Addenda: No. Berth 5 Project IFB Port of Port Arthur, TX v 25		
Date: November 15, 2017		
Question No:	Question Description:	Owner's/Engineer's Response:
1	Instructions to Bidders, Article 8, Liquidated Damages: states LD's are set forth in Agreement. However, it appears that LD's are not stated in Agreement?	Port has established a liquidated damages rate of \$2,700 per day for the Berth 5 project
2	Agreement, Article 5.1, Insurance: states that insurance coverages are detailed on attached Exhibit 1, Port Insurance Requirements. However, it appears Exhibit 1 is not attached?	See link on website www.portpa.com click on Public Notice and Insurance Requirements, Attachment A, Addenda 2
3	What are the insurance requirements for the project?	See link on website www.portpa.com click on Public Notice and Insurance Requirements, Attachment A, Addenda 2
4	Will a bid item list or bid breakdown be provided?	Bid item list/bid breakdown will not be provided

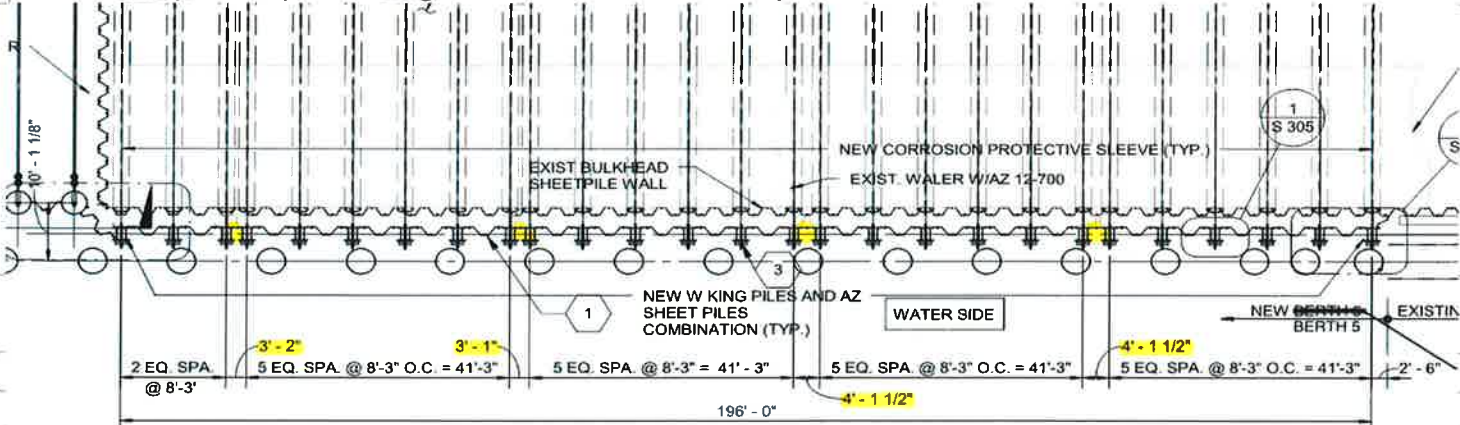
213	Insurance: Regarding Addendum 2 - Contractor Insurance Requirements, please confirm that the American Longshore Mutual Association (ALMA) will be acceptable as an insurance company providing USL&H coverage for work on this project. As an association, ALMA is not eligible for an AM Best rating as is required under Section 'B. Acceptable Insurance Company.' cont'd below	ALMA is acceptable by exception. All insurance companies utilized that are not in full compliance with the specifications are subject to review and approval from port risk management.
